TCEP Proj. #038-018-10

ADDENDUM NO. 1

NEBRASKA ARMY NATIONAL GUARD CATS FRONT GATE PROJECT

**CATS Front Gate Project
NEARNG Proj. #31090269**

C103

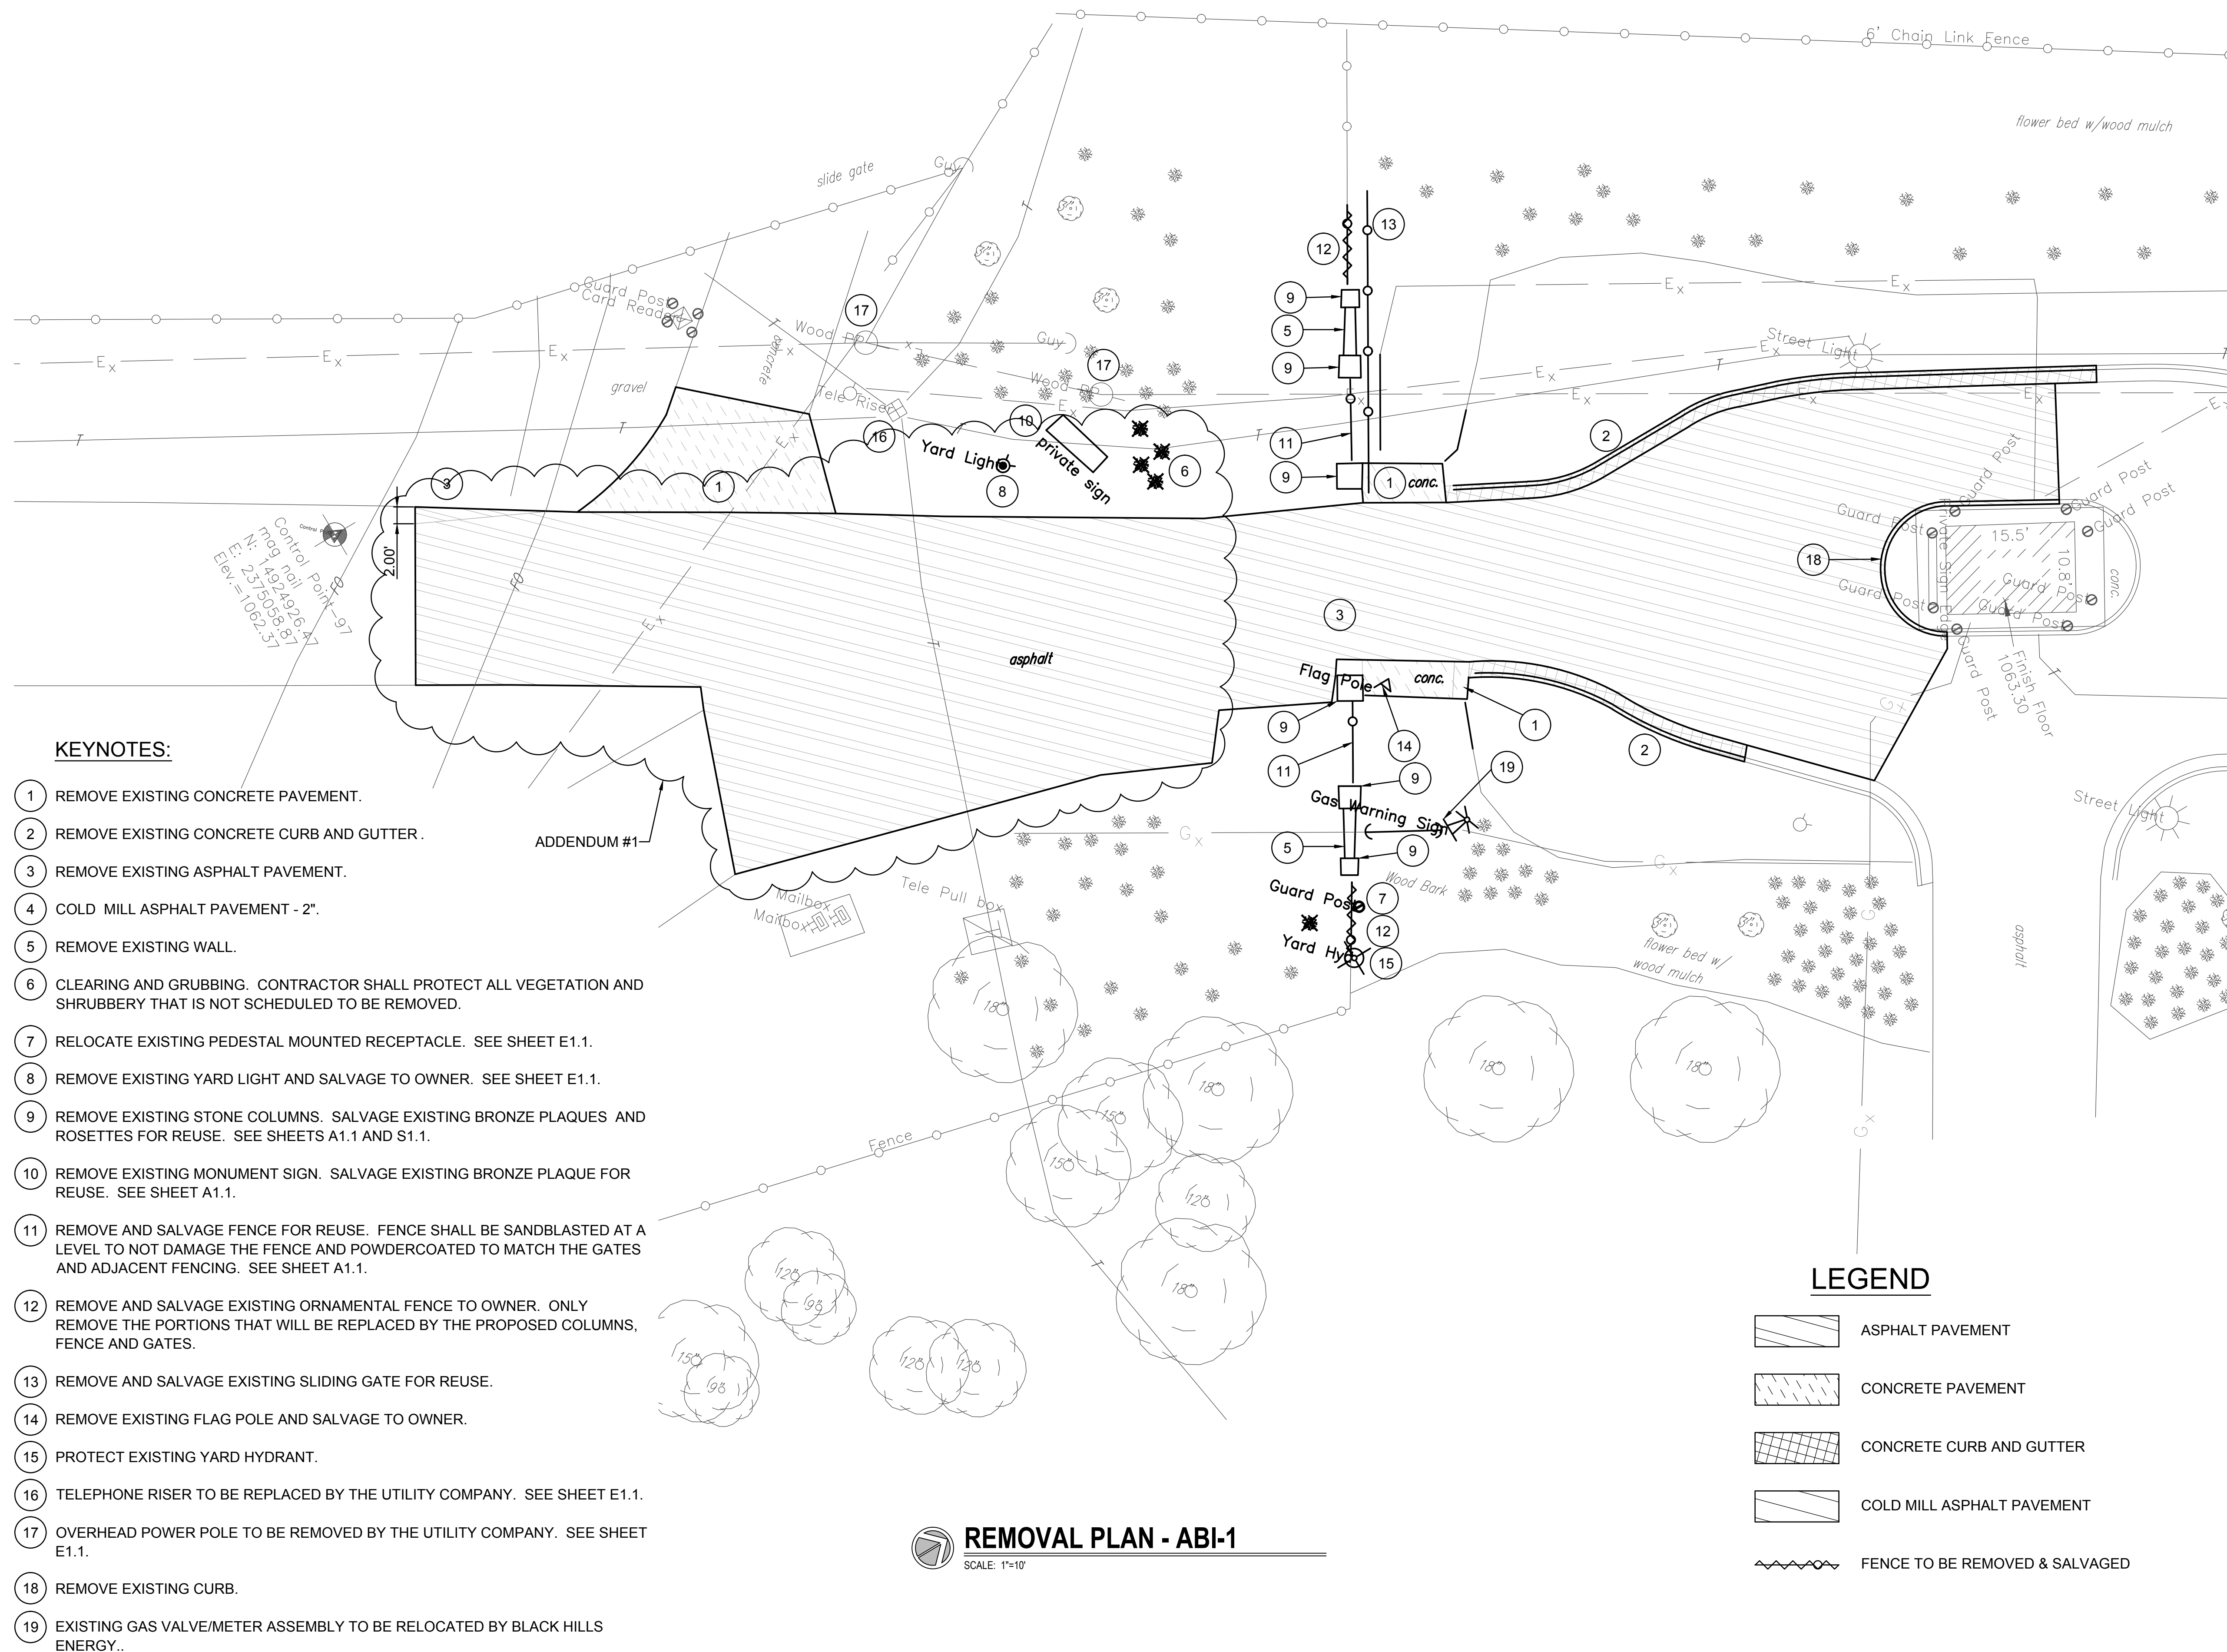
- Refer to Paragraph 3.1.A.1, Revise alternate to read: Provide asphalt paving in lieu of concrete paving as described on the drawings.
- Add Paragraphs 3.1.D and 3.1.D.1 as follows:

Item 1-4: Sheet C103

This sheet has been revised and reissued in its entirety as part of this Addendum.
